LIMITING CONDITIONS FOR OPERATION AND SURVEILLANCE REQUIREMENTS

### III. Retype of Proposed Changes

Seabrook Station Technical Specification 3/4.4.9, "Pressure/Temperature Limits" are currently calculated based on the methodology described in Revision 1 to Regulatory Guide 1.99. The proposed revisions to Technical Specification 3/4.4.9, mandated by the NRC in Generic Letter 88-11, are consistent with the methodology described in Revision 2 to Regulatory Guide 1.99. Revision 2 to Regulatory Guide 1.99 describes the general procedures acceptable to the NRC staff for calculating the effects of neutron radiation embrittlement of low alloy steels currently used for light water reactor vessels. Based on calculation performed for North Atlantic by the Yankee Atomic Electric Company Nuclear Services Divisions (YNSD) utilizing the methodology described in Revision 2 to Regulatory Guide 1.99 it was concluded that current heatup and cooldown curves do not require revision if the service period is revised to 11.1 Effective Full Power Years (EFPY) versus the current 16 EFPY. The YNSD calculations are available for review at Seabrook Station. The proposed revision to Figures 3.4-2, Reactor Coo

FIGURE 3.4-2

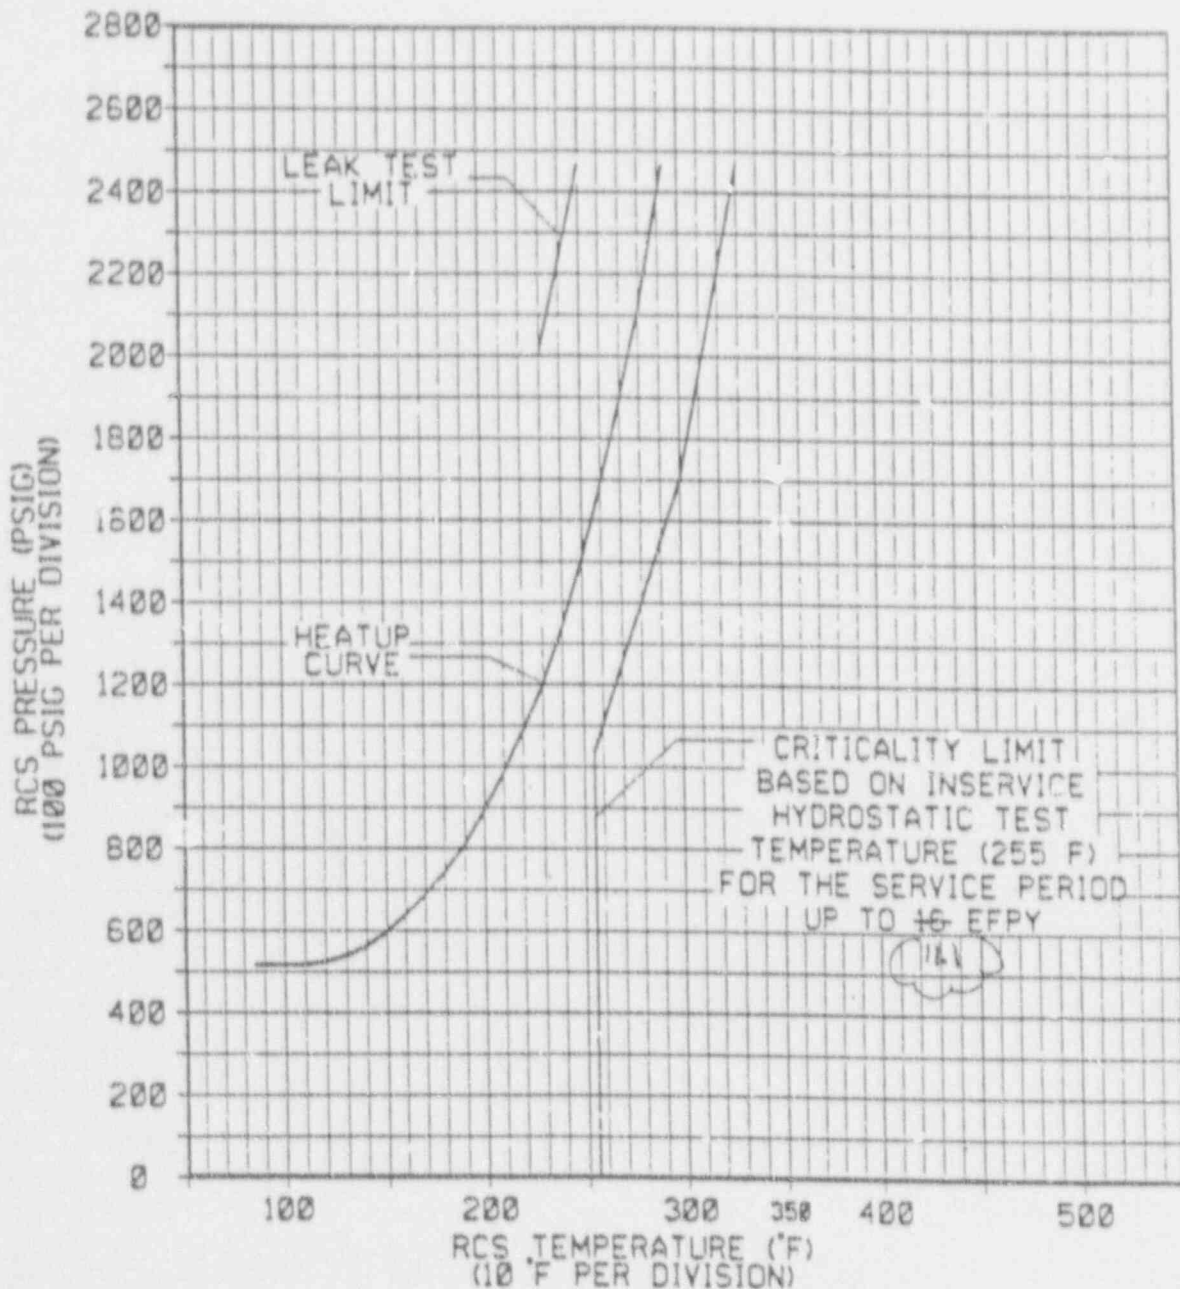
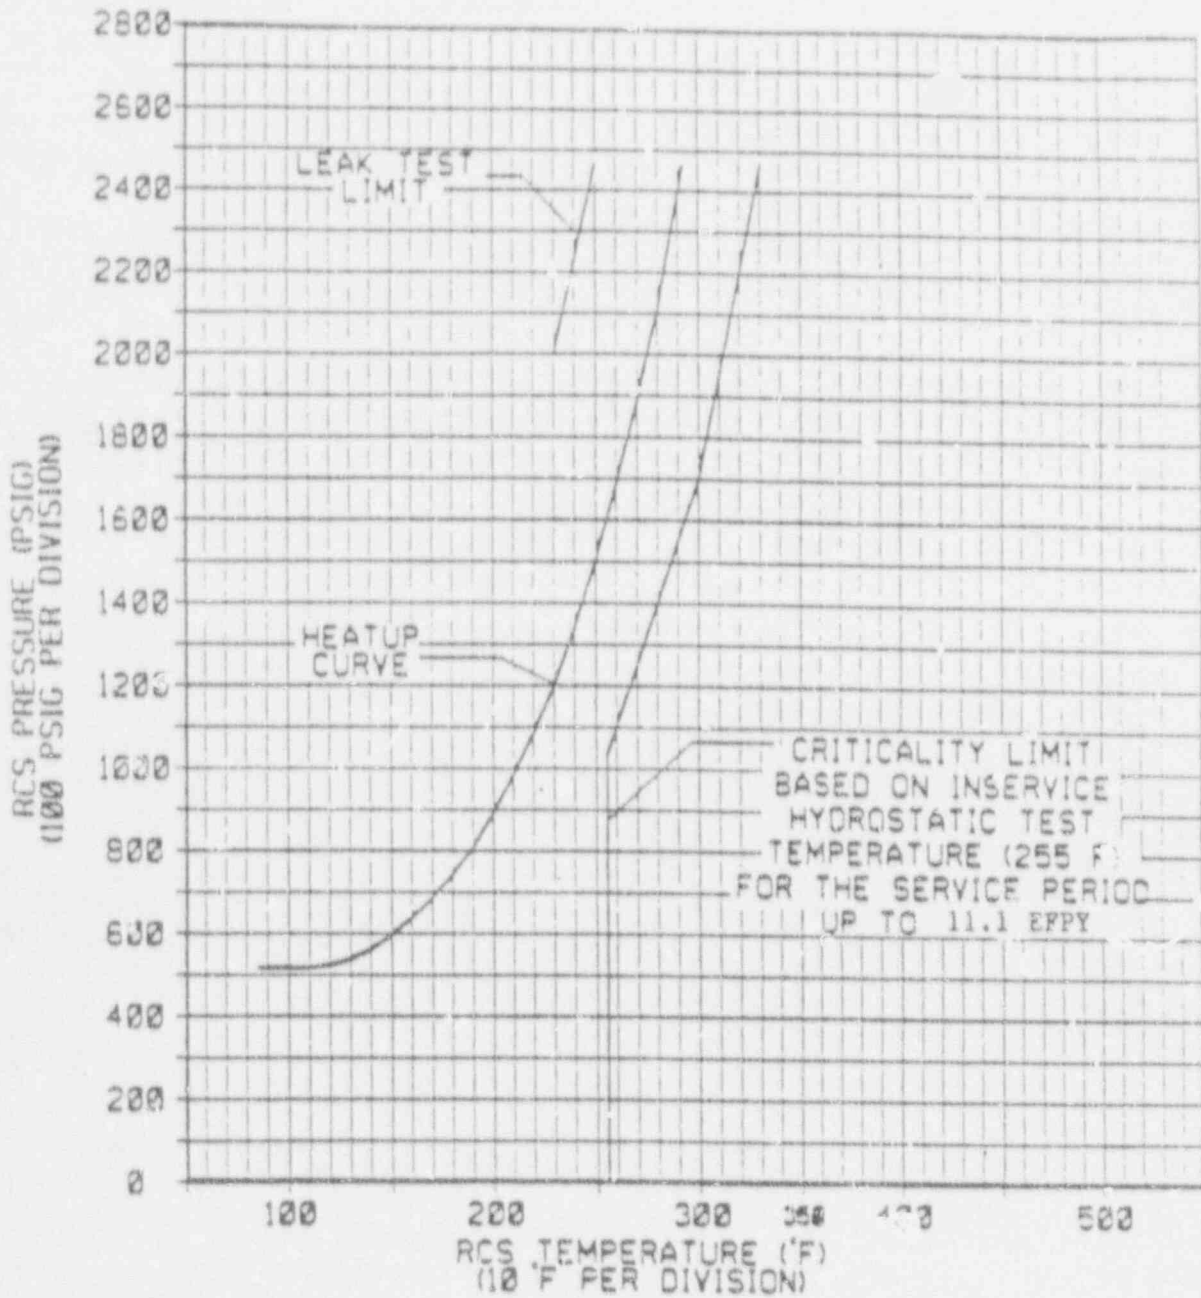
Base metal  
~~Conservatively assumed to be 0.10 WT% (actual 0.06 WT%  
content = 0.06 WT%)~~  
RT<sub>NDT</sub> initial: 40°F  
RT<sub>NDT</sub> after ~~16~~ EF<sub>FPY</sub>: 1/4T, 110°F 108°F  
11.1 3/4T, 87°F 86°F

Curve applicable for heatup rates up to 60°F/hr for the service period up to ~~16~~ EF<sub>FPY</sub> and contains margins of 10°F and 60 psig for possible instrument errors

REACTOR COOLANT SYSTEM HEATUP LIMITATIONS - APPLICABLE UP TO ~~16~~ EF<sub>FPY</sub>

Controlling material:	Base metal
Copper content:	0.06 WT%
PT <sub>NDT</sub> initial:	40°F
RT <sub>NDT</sub> after 11.1 EFPY:	1/4T, 108°F
	3/4T, 86°F

Curve applicable for heatup rates up to 60°F/hr for the service period up to 11.1 EFPY and contains margins of 10°F and 60 psig for possible instrument errors

REACTOR COOLANT SYSTEM HEATUP LIMITATIONS - APPLICABLE UP TO 11.1 EFPY

FIGURE 3.4-3

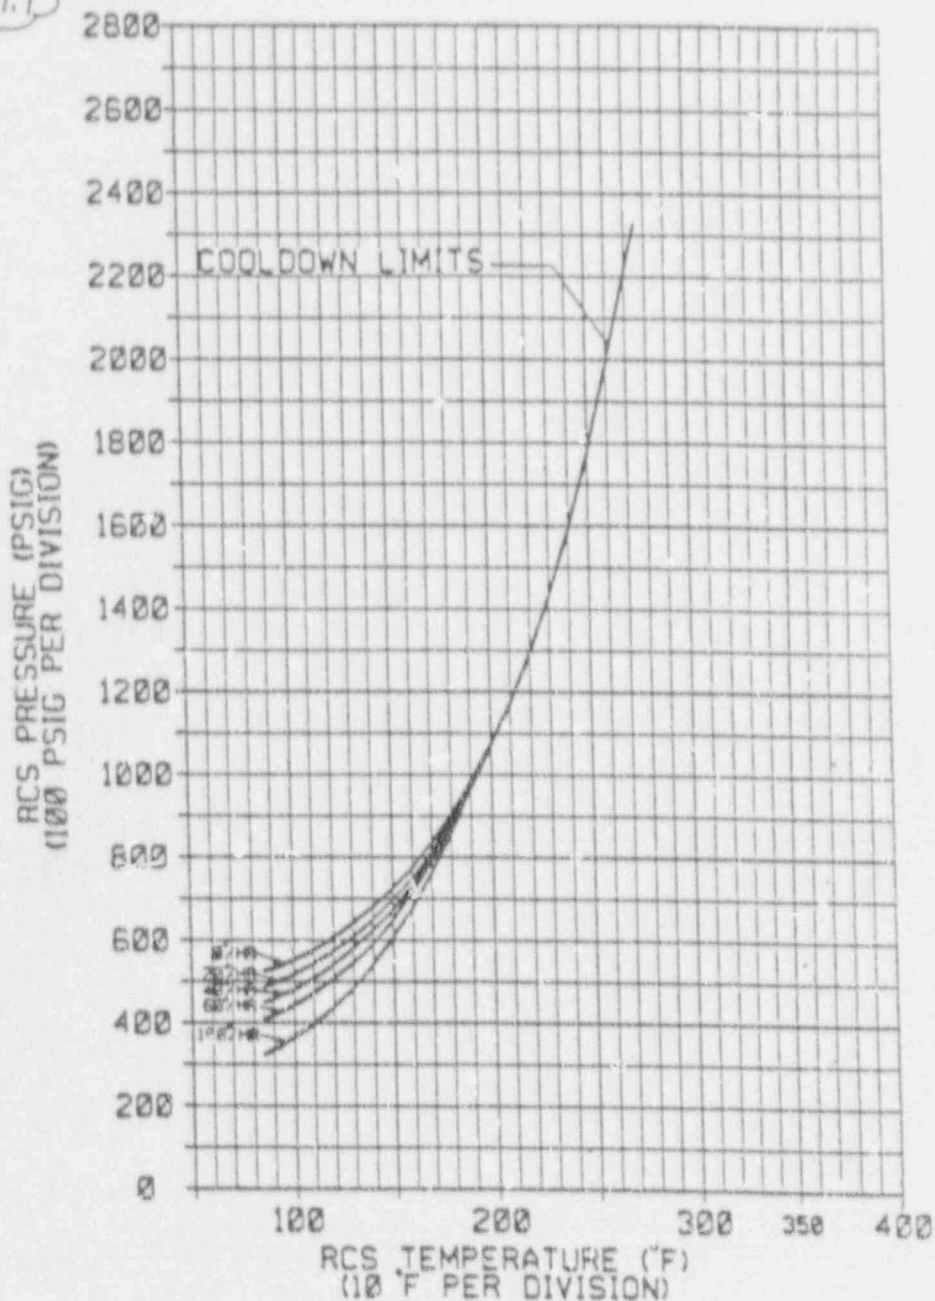
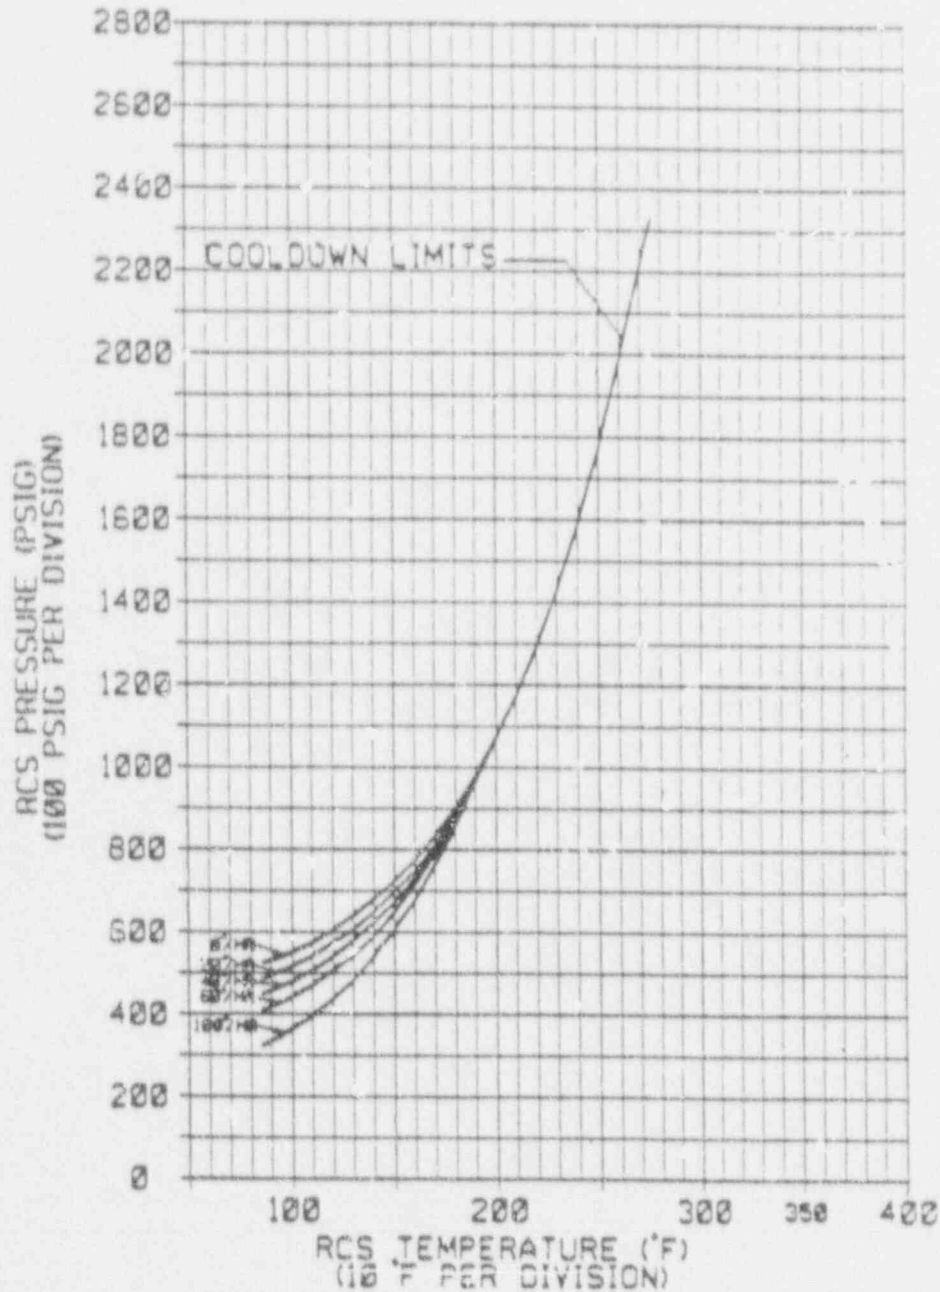
Controlling material: Base metal  
 Copper content: ~~Conservatively assumed to be 0.10 WT% (actual 0.06 WT% content = 0.06 WT%)~~  
 RT<sub>NDT</sub> initial: 40°F  
 RT<sub>NDT</sub> after  $\pm 6$  EFPY: 1/4T, 110°F 108°F  
 NDT 11.1 3/4T, 87°F 86°F

Curve applicable for cooldown rates up to 100°F/hr for the service period up to  $\pm 6$  EFPY and contains margins of 10°F and 60 psig for possible instrument errors

REACTOR COOLANT SYSTEM COOLDOWN LIMITATIONS - APPLICABLE UP TO  $\pm 6$  EFPY 11.1

Controlling material:	Base metal
Copper content:	0.06 WT%
RT <sub>NDT</sub> initial:	40°F
RT <sub>NDT</sub> after 11.1 EFPY:	1/4T, 108°F
	3/4T, 86°F

Curve applicable for cooldown rates up to 100°F/hr for the service period up to 11.1 EFPY and contains margins of 10°F and 60 psig for possible instrument errors

REACTOR COOLANT SYSTEM COOLDOWN LIMITATIONS - APPLICABLE UP TO 11.1 EFPY

FIGURE B 3/4.4-2

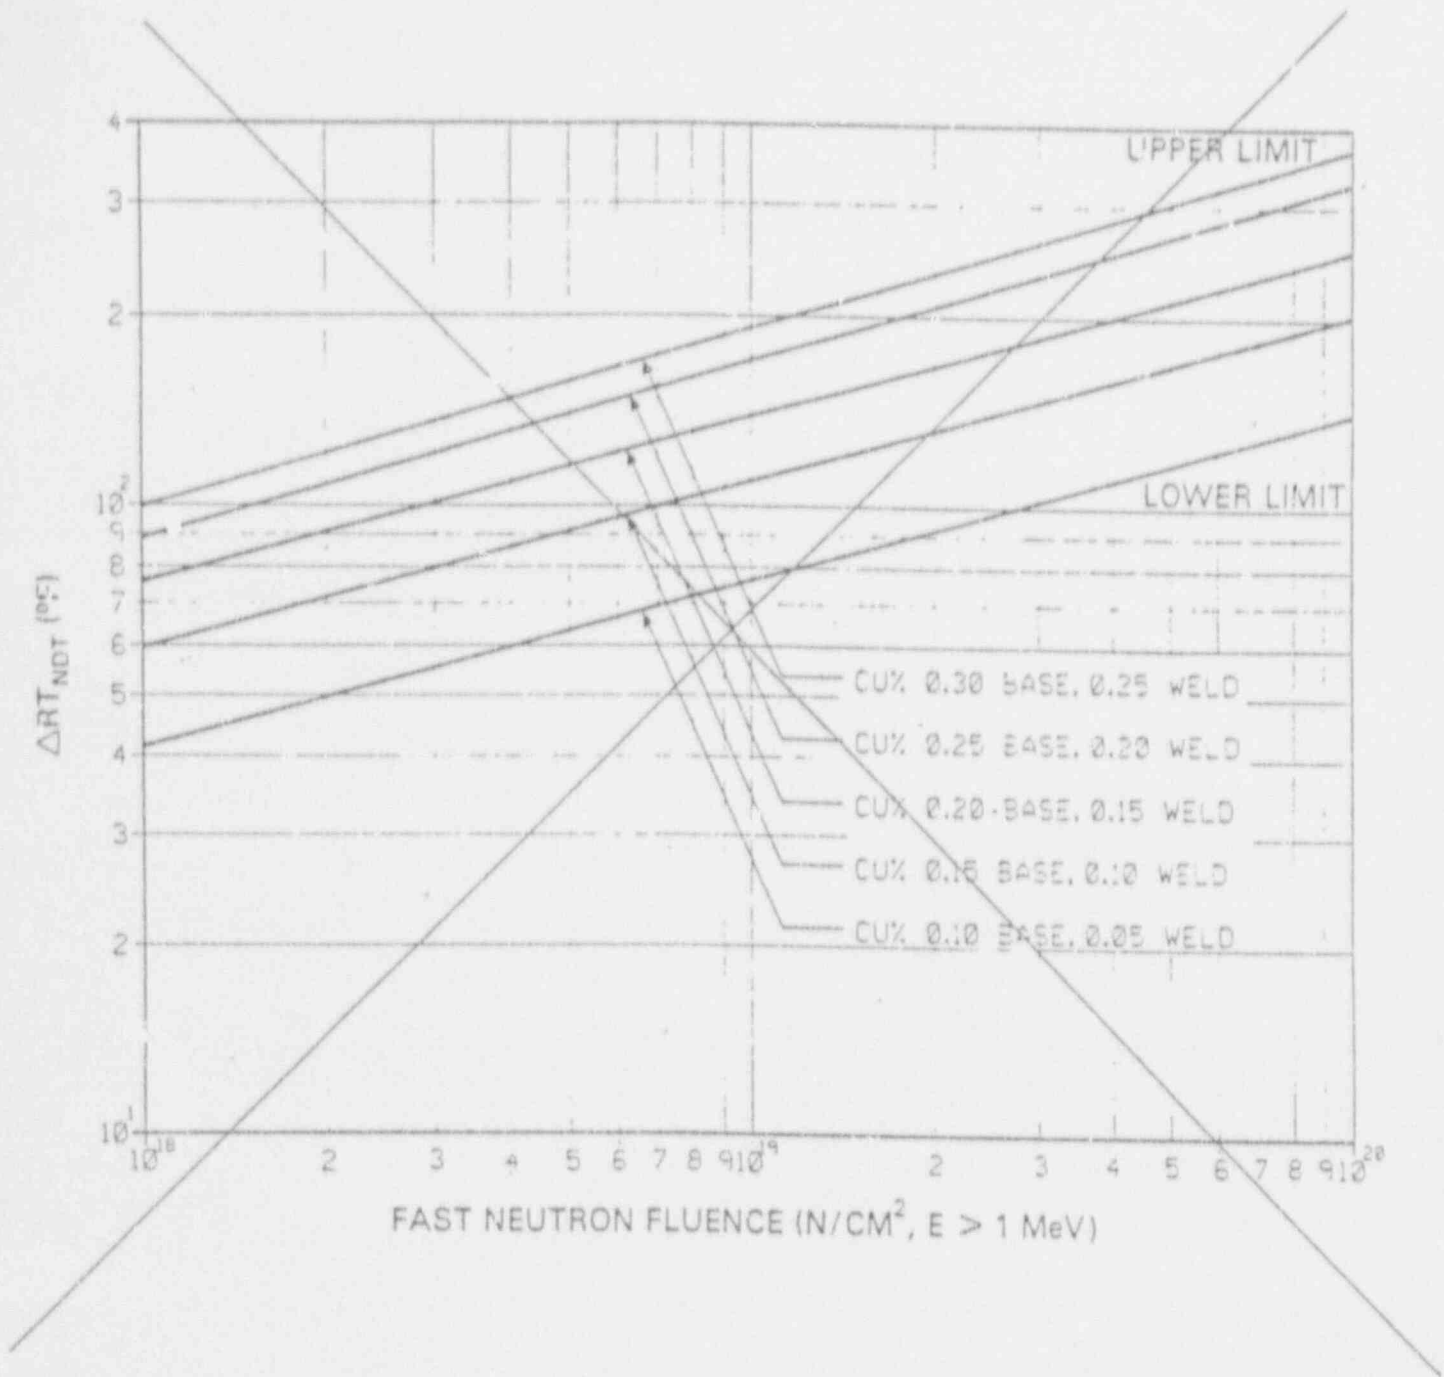
3/4.4.1 REACTOR COOLANT LOOPS AND COOLANT CIRCULATION.....	B 3/4 4-1
3/4.4.2 SAFETY VALVES.....	B 3/4 4-1
3/4.4.3 PRESSURIZER.....	B 3/4 4-2
3/4.4.4 RELIEF VALVES.....	B 3/4 4-2
3/4.4.5 STEAM GENERATORS.....	B 3/4 4-2
3/4.4.6 REACTOR COOLANT SYSTEM LEAKAGE.....	B 3/4 4-3
3/4.4.7 CHEMISTRY.....	B 3/4 4-5
3/4.4.8 SPECIFIC ACTIVITY.....	B 3/4 4-5
3/4.4.9 PRESSURE/TEMPERATURE LIMITS.....	B 3/4 4-7
FIGURE B 3/4.4-1 FAST NEUTRON FLUENCE ( $E > 1\text{MeV}$ ) AS A FUNCTION OF FULL POWER SERVICE LIFE.....	B 3/4 4-9
FIGURE B 3/4.4-2 <del>EFFECT OF FLUENCE AND COPPER CONTENT ON SHIFT</del> <del>OF RT<sub>NDT</sub> FOR REACTOR VESSELS EXPOSED TO 550°F.....</del>	B 3/4 4-10
<i>(This figure number not used)</i>

The Bases for Technical Specification 3/4.4.9 are revised to indicate that the heatup and cooldown curves are applicable for 11.1 EFPY and that the methodology described in Revision 2 to Regulatory Guide 1.99 was used to calculate the Reference Temperature for Nil Ductility Transition. Additionally, Figure B 2/4.4-2, Effect of Fluence and Copper Content on Shift of  $RT_{NDT}$  for Reactor Vessels Exposed to 550°F is deleted. The deleted figure was included in the original Seabrook Station Technical Specifications as an alternative to Regulatory Guide 1.99 for predicting the effects of radiation embrittlement on reactor vessel material. This alternative method is not used and its inclusion in Technical Specifications serves no purpose.

<u>3/4.4 REACTOR COOLANT SYSTEM</u>	
3/4.4.1 REACTOR COOLANT LOOPS AND COOLANT CIRCULATION. . . . .	B 3/4 4-1
3/4.4.2 SAFETY VALVES. . . . .	B 3/4 4-1
3/4.4.3 PRESSURIZER. . . . .	B 3/4 4-2
3/4.4.4 RELIEF VALVES. . . . .	B 3/4 4-2
3/4.4.5 STEAM GENERATORS . . . . .	B 3/4 4-2
3/4.4.6 REACTOR COOLANT SYSTEM LEAKAGE . . . . .	B 3/4 4-3
3/4.4.7 CHEMISTRY. . . . .	B 3/4 4-5
3/4.4.8 SPECIFIC ACTIVITY. . . . .	B 3/4 4-5
3/4.4.9 PRESSURE/TEMPERATURE LIMITS. . . . .	B 3/4 4-7
FIGURE B 3/4.4-1 FAST NEUTRON FLUENCE ( $E > 1\text{MeV}$ ) AS A FUNCTION OF FULL POWER SERVICE LIFE . . . . .	B 3/4 4-9
FIGURE B 3/4.4-2 (This figure number not used) . . . . .	B 3/4 4-10
